Charlotte Department of Transportation Memorandum

Subject: Rezoning Petition 15-069: Approximately 4.29 acres located on the south side of Shopton Road between Courtney Oaks Road and South Tryon Street

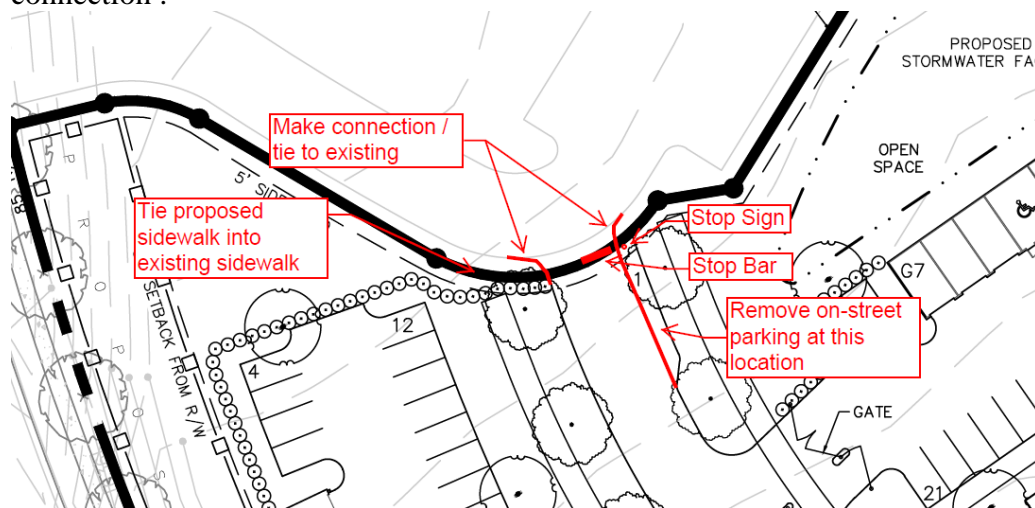
1. CDOT requests that the petitioner make the proposed private street connect to the existing driveway / Private Street on adjacent parcel as shown below in a concept sketch. The existing topography should be graded in a way that provides proper sight distance at this connection .
